John Tomlinson	<p><b>The proposed Multi-lot Subdivision for address 10 Fullarton Drive, Paynesville [lot C PS 311448] in its entirety</b></p> <p>Due to the landscape biodiversity and environmental vulnerability of the Internationally significant Ramsar wetland ecosystem with natural floodplain. It will be visually obtrusive (Clause 56.03-5) with regard to 'DDO-14' - as not a site responsive design for a rural village. Extra, large houses do not integrate with the wetland and lakeside environment, nor with the adjoining residential properties, as they will unreasonably deprive us of our wonderful amenity of a panoramic viewshed of wetland, lake and mountains.</p> <p><b>lot 51 and row of lots adjoining northern properties of Fullarton Drive</b></p> <p>The high, wide building envelope (16 AHD, or 4.5m) with full width orientation and only 10m rear setback (same as previous VCAT plan) severely impacts, infringes and obliterates the amenity of panoramic views which will be completely obstructed</p>	<p>Complete loss of amenity of magnificent constantly changing panoramic view (horizontal, vertical and oblique), encompassing vulnerable Ramsar wetlands, with a central focus on Fullarton Po

Sheet 14 of 30

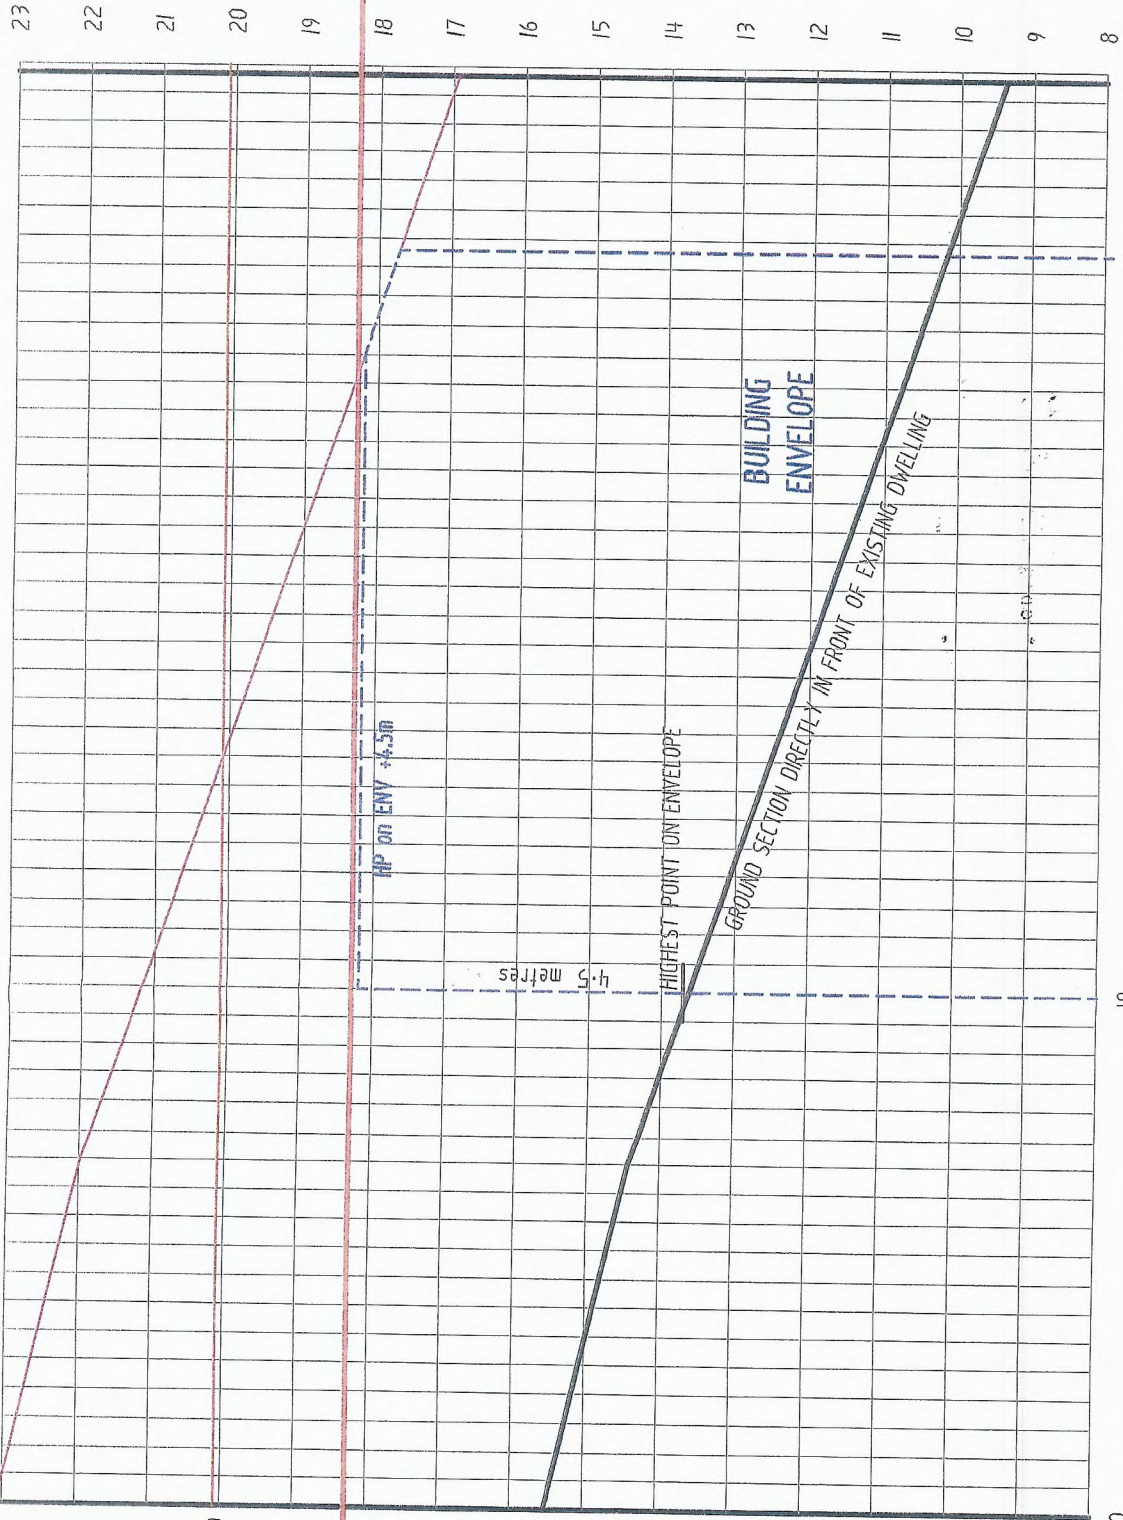
Objector	Grounds of Objection	How Objector will be impacted
	<p>The MODAN cross sectional drawings for numbers 12 and 28 Fullarton Drive have incorrect heights labelled and show that an 11 metre house could be constructed to the north of number 12 Fullarton drive. (Application Page 75/76)</p> <p>The worst case scenario, a house up to 11 metres as detailed on page 31 of the application is only possible due to the incorrect ffl height of number 12 Fullarton Drive.</p> <p>These cross section drawings apart from being inaccurate do not demonstrate how views will continue to be shared and enjoyed by adjacent properties and the proposed allotments as stated on application Page 31. There is no outcome to the horizontal viewing line shown.</p> <p><b>The incorrect assumption that a horizontal viewing line gives properties a view sharing opportunity.</b></p> <p>Statement( page 31 application) The maximum height will not exceed the standing eye level of the immediately adjacent building.</p> <p>A horizontal viewing line from a standing eye level of 1.5 metres above floor level gives at best a view of part of the hills beyond the lake and the sky. It does not include the lake or any wetland view. The importance of the viewing line angle is vital. To obtain a view, the viewing line must be angled towards the view required. (see included photos)</p> <p>The photos included were taken by Bruce Bowden of Austech Surveying in Bairnsdale and were used at VCAT 2014 to illustrate the problem of a horizontal viewing line. The theodolite he used had a built in camera. The horizontal view in both photos demonstrate that the views obtained do not include the lake or Ramsar wetland.</p> <p>An oblique viewing line suitable to each individual house is required and the appropriate AHD designated.</p> <p><b>There is nothing in the plan to prevent further subdivision of blocks into battle axe style blocks which would increase density to an unacceptable level as well as threaten any view sharing opportunities.</b></p> <p>Battle axe blocks do not fit with the neighbourhood character of this area as described in the application page 39 - The neighbourhood character of northern Paynesville district area is categorised in general by single lots with detached dwellings. A restriction on the title is required to ensure that further subdivision is not possible.</p>	<p>This panorama of very high quality needs to be considered in terms of what views will be lost and what views would be retained.</p> <p>In addition my enjoyment of observing the variety of wildlife in the adjoining paddock, including mobs of kangaroos, endangered JAMBA migratory bird the Latham's snipe which forages in the wet grasses and shelters in the low bushes, echidnas and bluetongue lizards will only in future be a memory. As a long time resident I care deeply about this special environment and request that council consider carefully the environmental values of the whole area.</p> <p>If this application is approved the reserve and wetland area will become the exclusive and unencumbered view and amenity of the dwellings to our north.</p> <p>The applicant should be made to prove to adjacent owners just how much view we will retain in the view sharing situation that the application proposes. The VCAT panel visited my property in 2014 and made an assessment using 4.5 metre poles which did give me an indication of the amount of view I would lose. Since that assessment the subdivision has been redesigned which has significantly changed the lots immediately to the north of my home. Therefore before any approval is given council must require at least a similar assessment.</p> <p>The block next door to me on the eastern side was designated to be the road into the subdivision in the previous design. It is now to be a regular house block (Lot 59) and will be offered for sale after approval of this subdivision. It is interesting to note that the</p>

Objector	Grounds of Objection	How Objector will be impacted
	<p>Ref: date 6/8/2022 Version 3 – 28-30 Fullarton Drive [Appendix 5] Clearly the data shown on the view line section drawings for houses 12 and 28 are incorrect.</p> <p>These drawings may not be excused as [refer to note on drawing]</p> <ul style="list-style-type: none"> <li>Plans are indicative only</li> <li>Finished surface levels are subject to engineering design</li> <li>Survey produced by Crowther and Sadler</li> </ul> <p>That this practice may be the ‘norm’ under planning permit application processes, it does not provide an accurate representation to affected residents nor the EGSC.</p> <p>It is not acceptable that inaccurate information or resources affecting the permit decision process are submitted to EG Shire Council</p> <p>2. Potential for new landowners to further subdivide individual lots Although this new subdivision plan is conceived and designed by the Planners and Developer to meet planning scheme policy and guidelines, I submit that the planned subdivision does not meet all the criteria. The future subdivision by new lot owners on the larger m<sup>2</sup> lots [or any other] should be avoided due to the potential of increased built form bulk, landscaping intrusion and impact on the Ramsar Wetland and adjacent Crown lands.</p> <p>The DDO14 clearly provides guidelines for design objectives and Councils decision Schedule 14 to the Design and Development Overlay – DDO14 Residential Development in Coastal Settlements: Paynesville</p> <p>Significant Landscape Overlay The Paynesville Growth Area Structure Plan was adopted by EGSC on 2 August 2016. On Page 28, under sub heading Statutory Implementation, details of the process for implementation are stated including: <i>3.2 Amend the Municipal Strategic Statements – amongst others</i></p> <p><i>3.2.3 Removal of the Significant Landscape Overlay Remove the SLO affection land within the Structure Plan areas.</i></p> <p><i>3.2.4 Apply a DPO and Schedule for Residential areas a. Apply Development Plan Overlay [DPO] to land affected by the Paynesville Growth Area Structure Plan.</i></p>

Julie MacKay	<p>The Modan drawings for the Fullarton Drive residences, 12 &amp; 28 (there maybe others as well) are incorrect and therefor do not give an accurate impression of the sight line and horizontal view for view sharing opportunity. The 1.5 metre horizontal sight lines from our floor level height does not provide a reasonable view share situation and is some cases, none. An oblique sight line would provide a better view. Further subdivision of any new lot has not been a part of the consideration for inclusion on a Section 173 or covenants on new lot titles. The 18 metre rear seat back proposed for some adjoining properties has being omitted. These were numbers 18-42 Fullarton Drive. Concerns for the negative impact on existing and potential wild life in the area particularly kangaroos and local bird life. Increase in local traffic on roads that are often under repair indicating inability to cope with existing traffic conditions let alone an increase. Concerns over negative impact on environment including land, air and unique East Gippsland water ways. Climate change and global warming potential for water level rises and increase risk of further environmental crisis'. Including potential increase risk of flooding.</p>	<p>Reduced quality of life, impact on mental health, considerable financial hardship resulting in possible moving away from the area.</p>

REF 14120/28  
SHEET 2 of 7 SHEETS

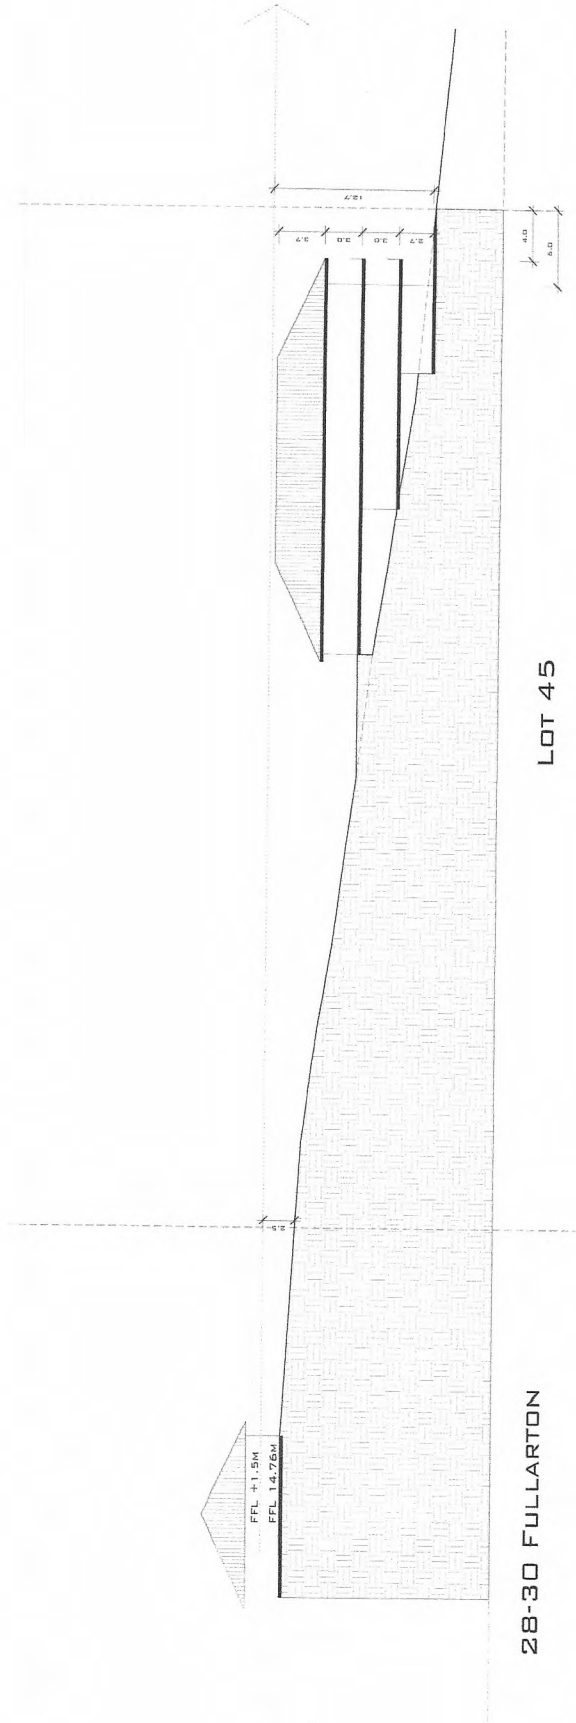
Objector	Grounds of Objection	How Objector will be impacted
	<ul style="list-style-type: none"> <li>• <i>A view line section of each Fullarton Drive property from the applicant based on a survey of floor level at the centre of the north façade of each Fullarton Drive house; and</i></li> <li>• Served view lines of seven Fullarton drive houses from the residents.</li> </ul> <p><i>Footnote 20: This was discussed orally in the hearing on 18 July 2014. Our order dated 23 July 2014 gave leave to the applicant to provide any further materials (such as illustrations, facts relied upon and methodology of preparation) that it wishes to rely upon in regard to the issue of view sharing.</i></p> <p>This plan was supported by Section site line drawings showing the 18 metre setback for northern resident lots 18-42. [Appendix 2] For this purpose, I provide drawings for 28 Fullarton Drive.</p> <p>This evidence supports the amendment to the newly proposed building envelopes from 10m to 18m rear setback for the lots 50-39.</p> <p>1. Building envelopes In its finding in VCAT Order dated 4 August 2011, after considering the first application for a planning permit by Lake Park Holdings, the members found in favour of the residents' submission that views of Lake King form part of the resident's amenity</p> <p>This outcome was influenced by the 'in perpetuity covenant of a building height of 4.5m at highest part of the land' on titles for houses on the southern side of the new subdivision. The covenant still limits any improvement in our ability to address the view amenity in a different way.</p> <p>Extract: Page 17 Para 56 <i>The Council explained DDO14 contains no reference to the sharing of views but submitted that this could be achieved through the incorporation of appropriate building envelopes in the subdivision. The Council did acknowledge that the lack of any reference to the sharing of view in the planning scheme limits the amount of weight that can be given to this issue in considering the planning merits of this proposal. Nevertheless, we appreciate the Lake King views from part of the amenity of the residents' properties.</i></p> <p>b. View [sight] lines In response to the revised building envelope plan, approved at the VCAT hearing of 14 August 2014, the residents engaged Austec Surveying, Bruce Bowden, and submitted his methodology report and a copy of the plan of the subdivision</p>

Objector	Grounds of Objection	How Objector will be impacted
	<p>showing the surveyed direction across the lots from the residents' homes, to demonstrate a view line into the centre of the wetland. [Appendix 3]</p> <p>The residents 18submitted to VCAT drawings indicating both horizontal set at 1.2m and oblique view lines which clearly showed the difference a 20 angle makes to view sharing. [Appendix 4] for this purpose I provide drawings for 28 Fullarton Drive.</p> <p>I refer you to the VCAT Order dated 21 November 2014. Pg.23 Para, 78 – Sitting or Standing Views. Pg.24 Para 79/81 – Overall Views Pg 24 Para 82/83 – Vertical View Corridors or Horizontal Views</p> <p>Extract: Pg 25 Para 83 <i>What this means is that we have given more weight to the horizontal view proposed to be maintained in light of the current panoramic views available to each Fullarton Drive house. The current view is what we would describe as a whole view in which the interface between land and water is visible and appreciated in a wide, often panoramic viewshed. The current view is commonly available from rear decks and principal living areas in both sitting and standing views.</i></p> <p>Extract: Pg 27 Para 87 <i>Almost half of the houses.... Given this proposal is a large subdivision with limited constraints, particularly on the southern part of the site other than for topography we are not persuaded the extent of impact on view sharing achieves a reasonable outcome. Whilst it may not be reasonable to expect that the impact on each house is entirely equal, we are of the opinion a review of the detail of the subdivision layout should be able to achieve a more acceptable extent of impact across each property than that contained in this proposal.</i></p> <p>Because the residents on the southern side of Fullarton Drive are beneficiaries to the restrictions constraining residents on the north side, we will be sandwiched with the new subdivision with extremely limited view sharing opportunity.</p> <p>This evidence supports the amendment to oblique sight/view lines on all abutting lots to all northern houses on Fullarton Drive.</p> <p>1. Building envelopes c. View [sight] lines drawings submitted within this permit application</p>
